ADDENDUM #1

Project: 2012 Architectural & Electrical Renovations – Hudson Area Schools

Hudson, Michigan

Engineer: Dailey Engineering Inc.

A1.6

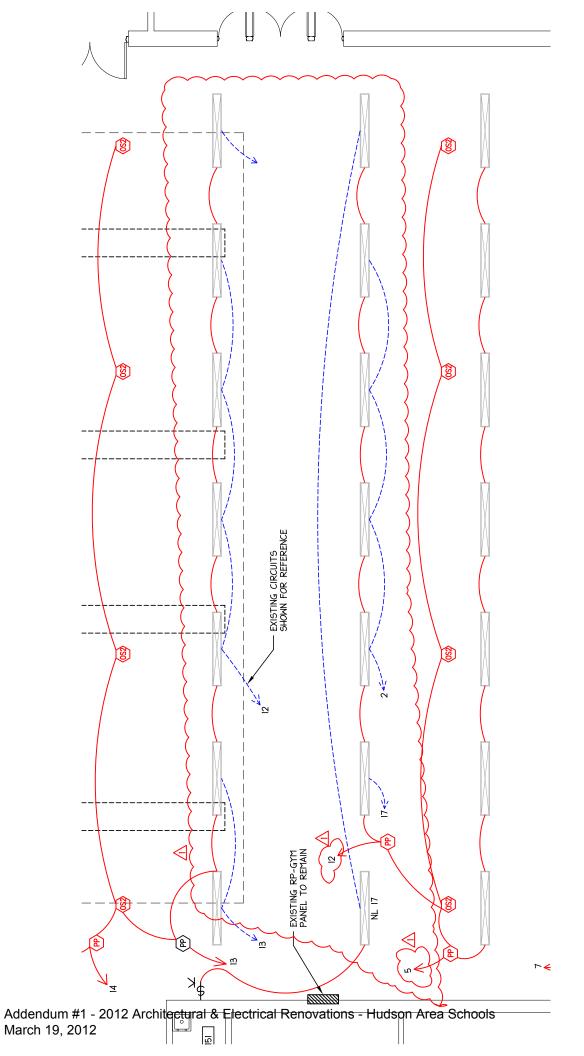
- 1. Drawing 200-A6.2 is revised as shown on page A1.4 of this addendum.
- 2. Drawing 200-E3.1 note 9 is revised as follows: ...see specification section 16820 for more detailed description.
- 3. Drawings 100-E1.1 and 100-E1.2: The legend has been revised as shown on page A1.5 of this addendum to give a mechanical design drawing reference.
- 4. Drawing 200-E1.1: The plan has been revised as shown on page A1.6 of this addendum to add some additional circuit numbers.
